SUNDRY NOTICES AND REPORTS ON WELLS	0
Do not use this form for proposals to drill or to re-enter an	
bandoned well. Use form 3160-3 (APD) for such proposals.

# Delaware Basin Changes to APD for Federal Well

Salado	<b>Draw</b>	29	26	33	#1H	API#:30-025-42629
Salado	Draw	29	26	33	#2H	API#:30-025-42637
Salado	Draw	29	26	33	#3H	API#:30-025-42638
Salado	Draw	29	26	33	#4H	API#:30-025-42639

## Summary of Changes to APD Submission

## **Batch Drilling Sequence**

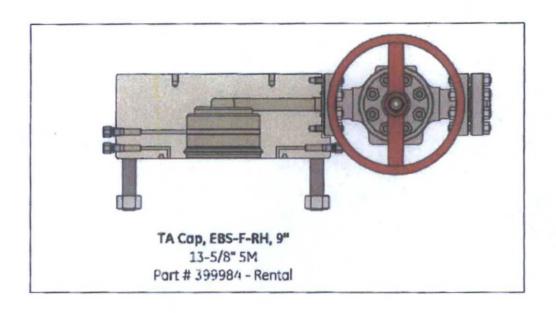
Summary: Variance to batch drill the Salado Draw pad not requested in original submittal.

Variance to batch drill not requested.

Chevron respectfully request the ability to batch drill in the SALADO DRAW 29 26 33 PAD (4<sup>TH</sup>). The summary provided is a brief description of the main operational sequences for drilling and casing the four wells listed.

Once the Rig is on location, it will drill the above mentioned wells in conjunction using batch drilling.
